Project Name:	Coldharbour Farm Road, Emsworth
Document Reference:	187.0018/TN/2
Document Name:	Transport Note
Prepared By:	Mark Smith (May 2026)
Checked By:	Mark Smith (May 2026)
Approved By:	Mark Smith (May 2026)

Designers Response Road Safety Audit
Coldharbour Farm

Road Safety Audit Report

Proposed Continuation of Coldharbour Farm Road Emsworth

DISCLAIMER NOTES:

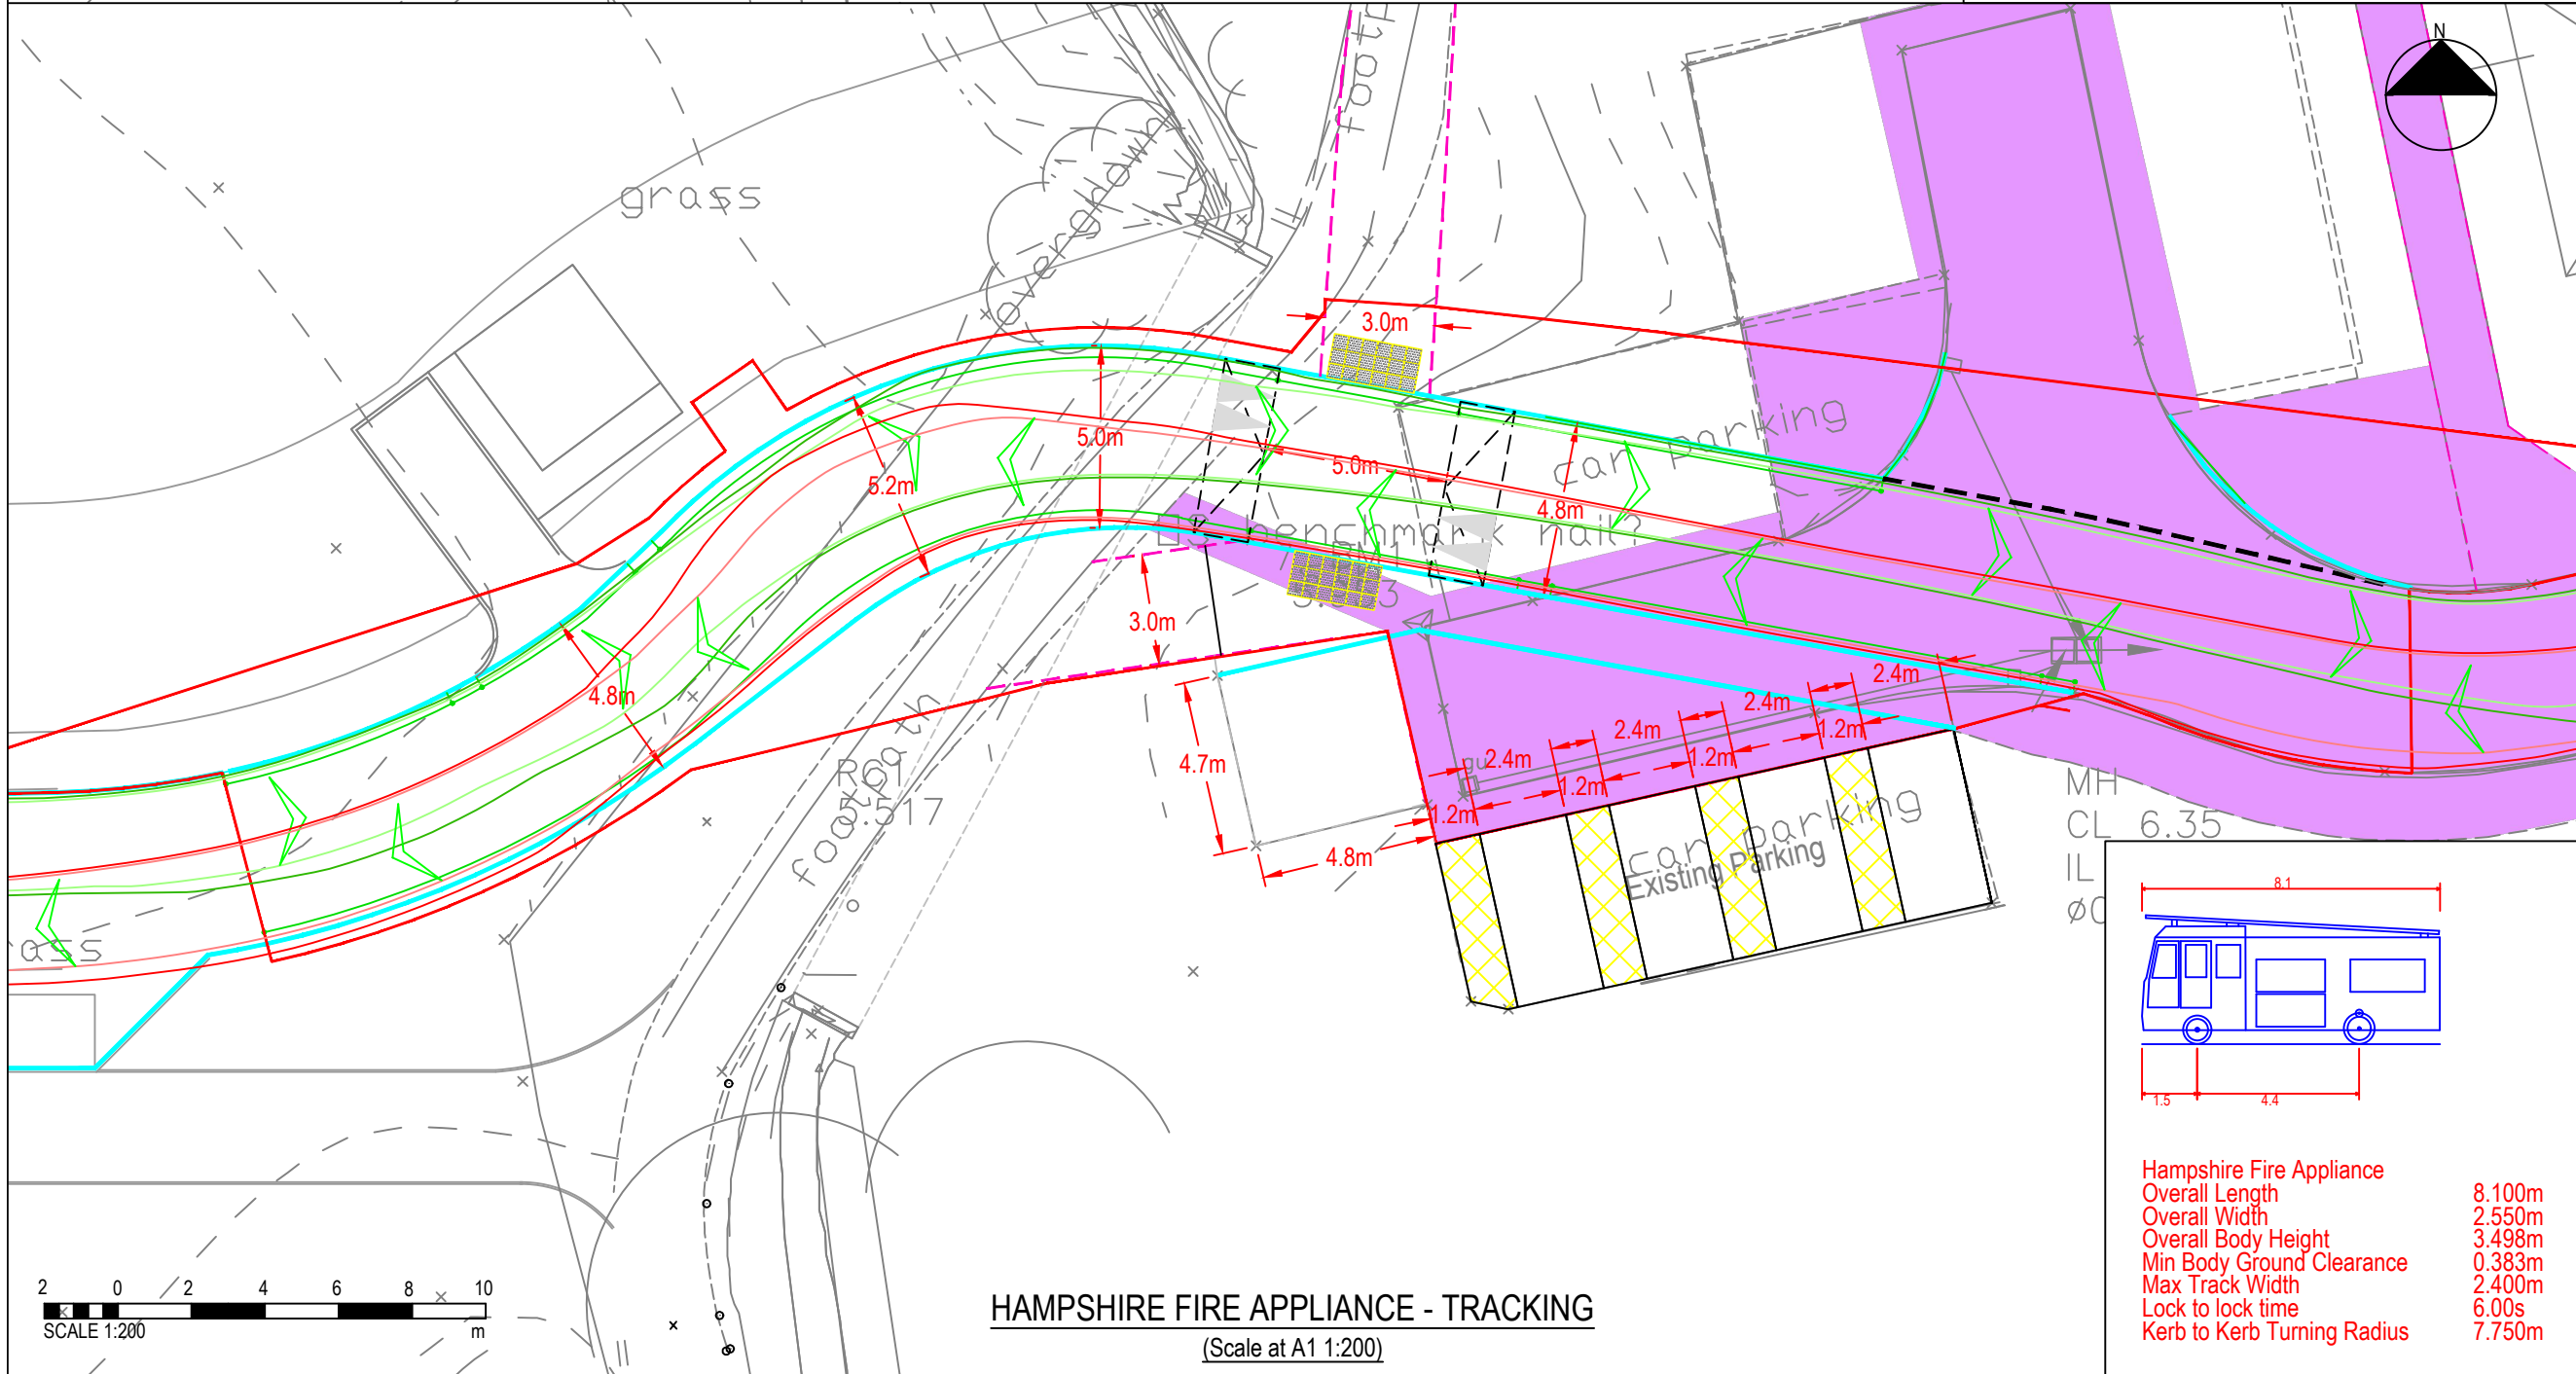
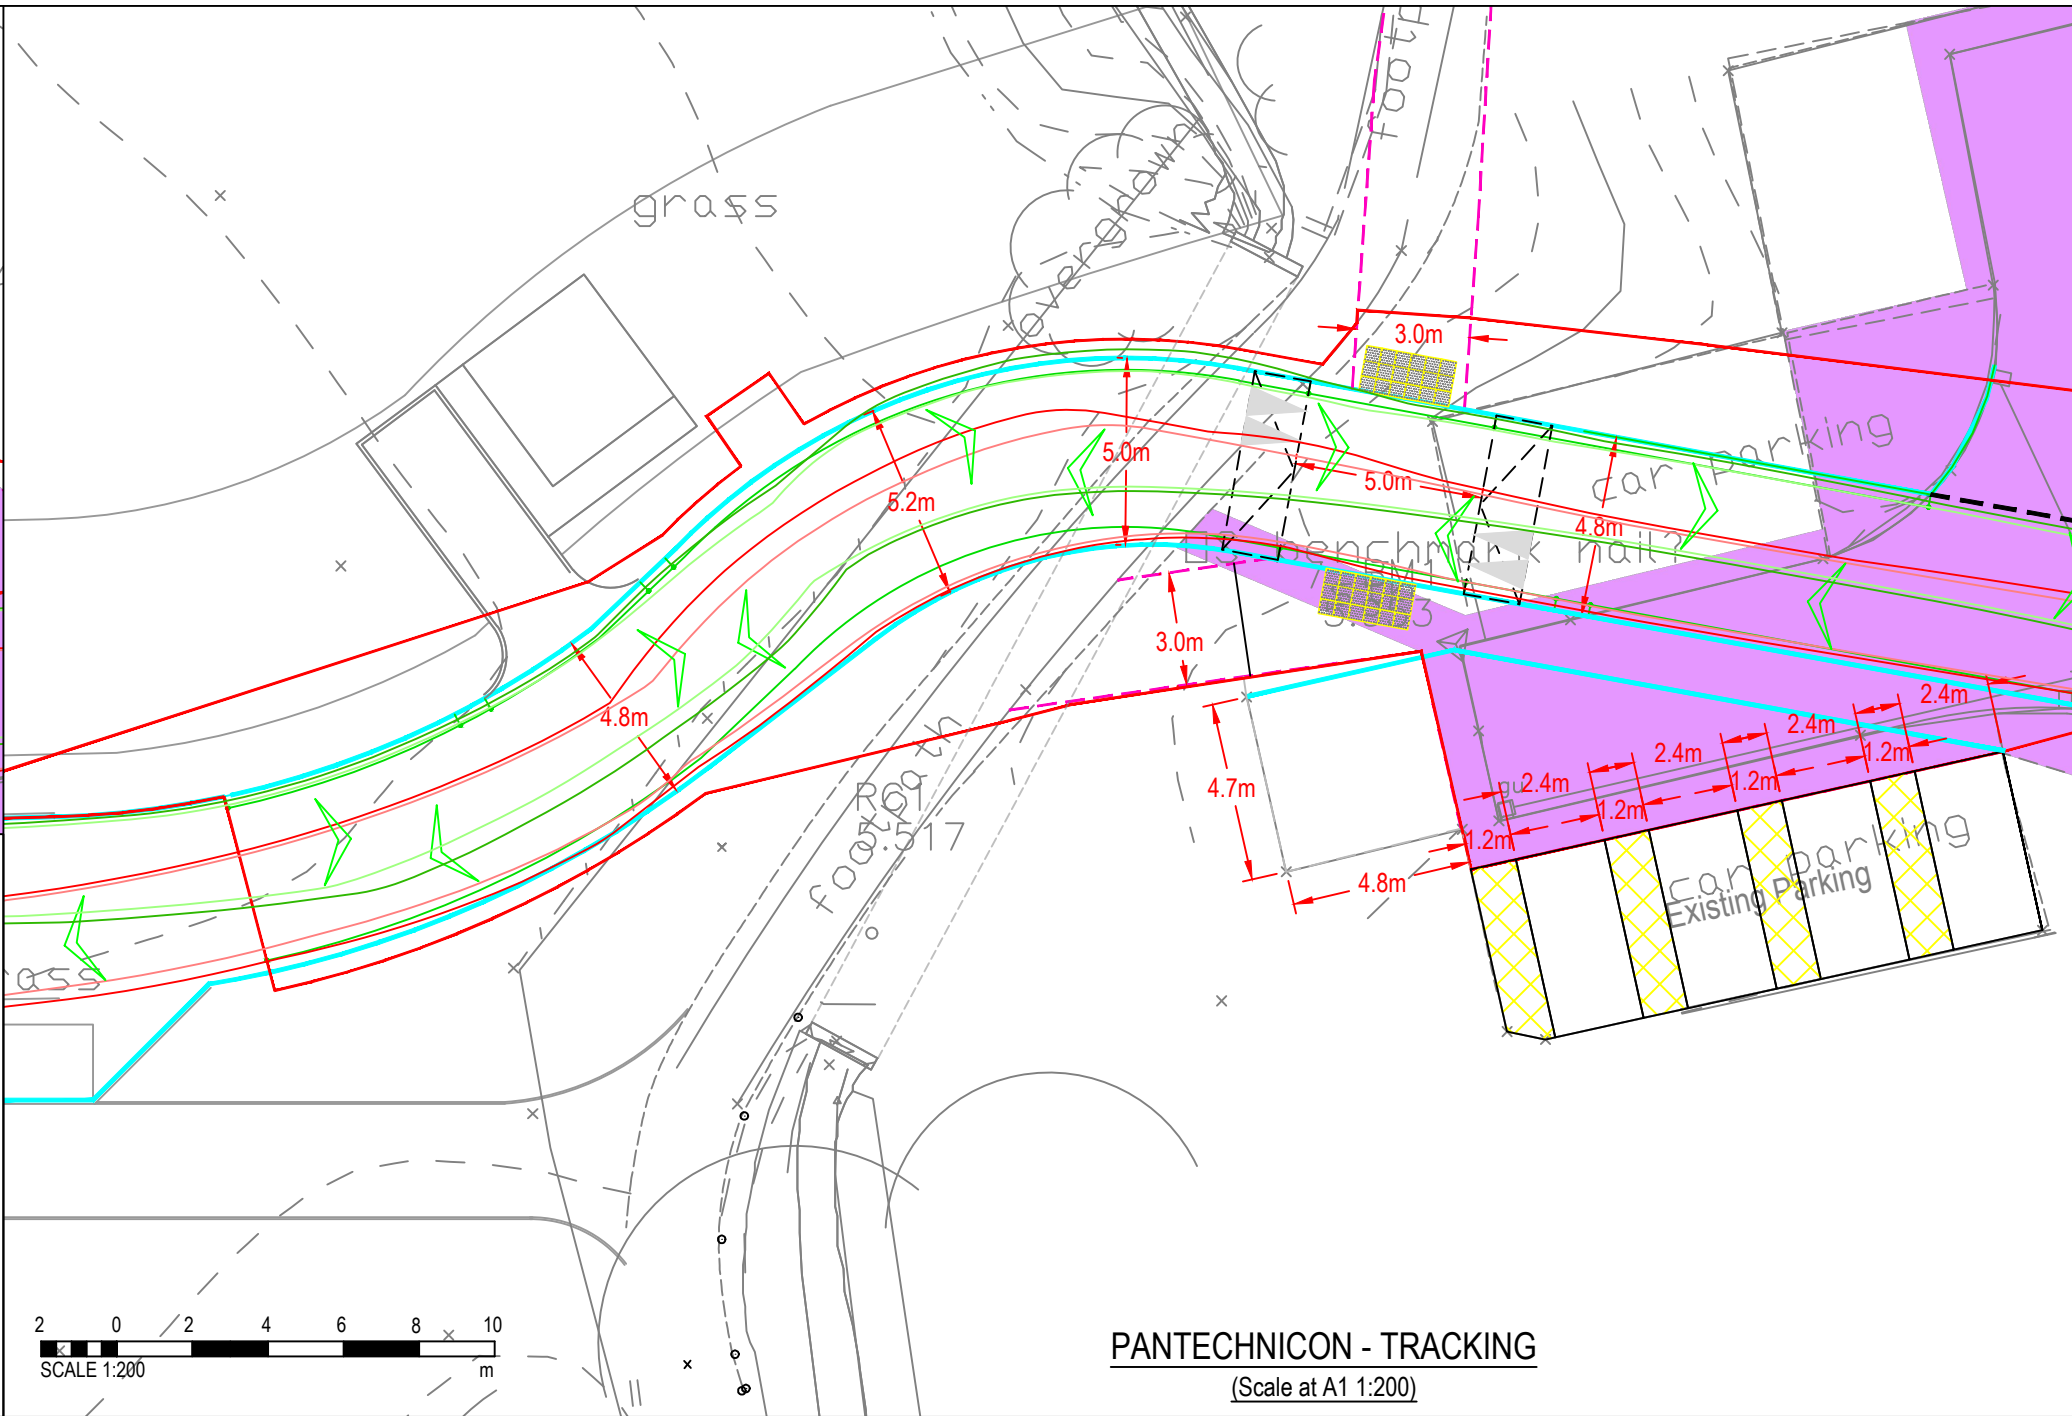
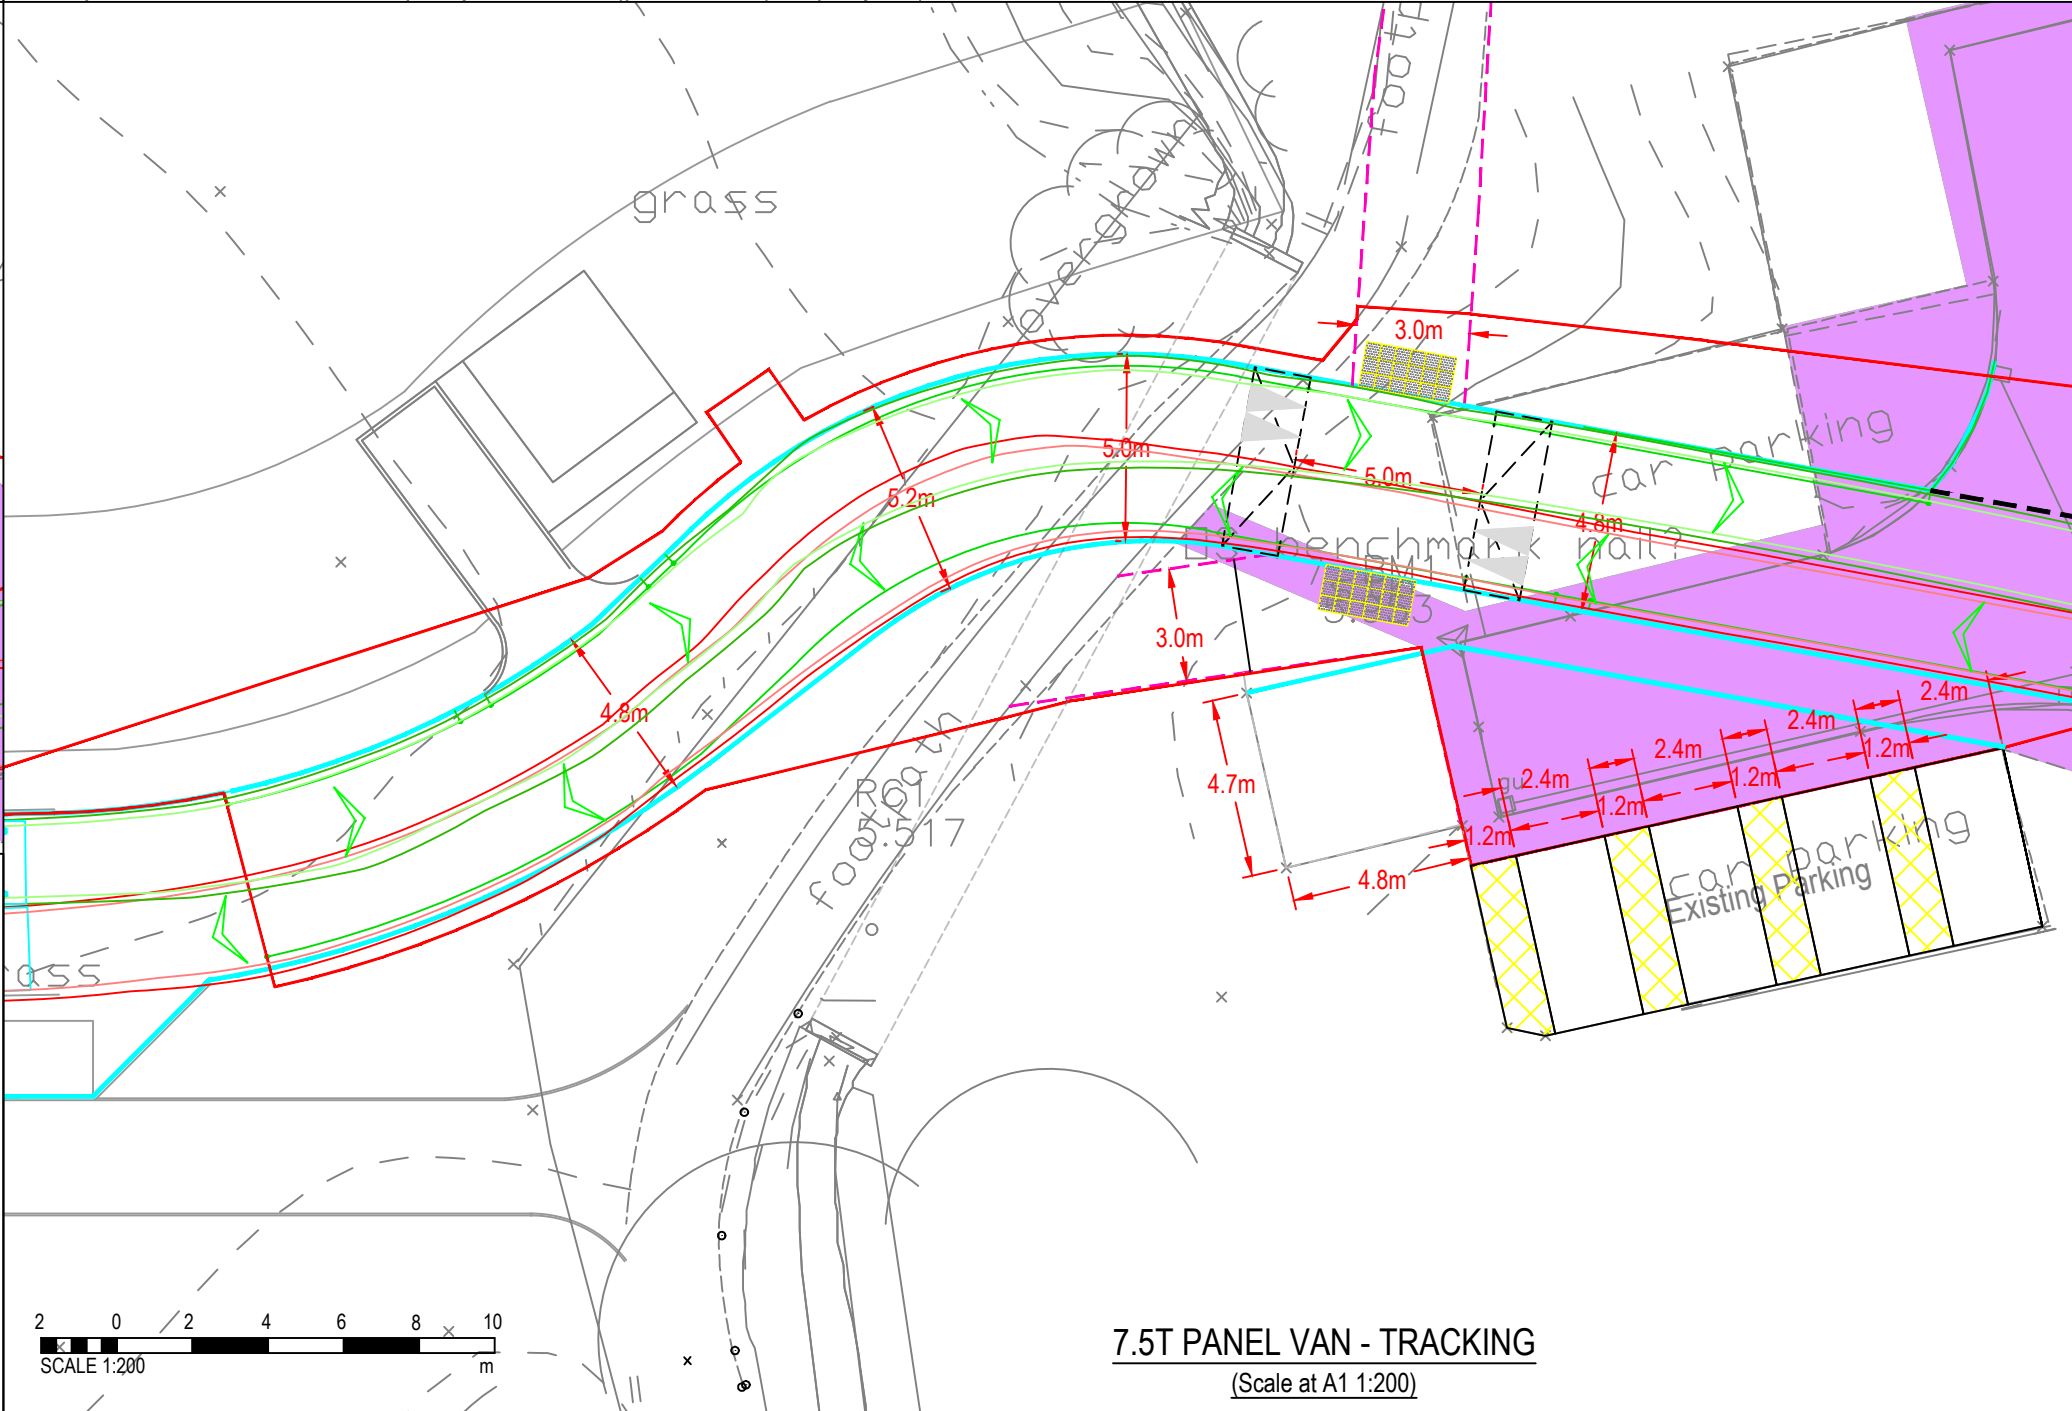
B.4.1 - Cyclists are likely to continue without giving way to traffic. It is recommended that an appropriate level of visibility is achievable.

B.4.2 - Non-motorised users at and on approach to the uncontrolled crossing may not be clearly visible during the hours of darkness. It is recommended that visibility is achievable to the tangent and that the proposed crossing point is illuminated adequately with a column provided immediately to the west of the crossing point as previously proposed.

Suitable visibility splays for cyclists are as shown on Drawing 23339-JUBB-XX-XX-DR-X-000100 REV C13. In dashed orange. With regards to lighting, this has been confirmed as suitable by the lighting designer.

Suitable visibility splays for pedestrians are as shown on Drawing 23339-JUBB-XX-XX-DR-X-000100 REV C13. In dashed yellow. With regards to lighting, this has been confirmed as suitable by the lighting designer.
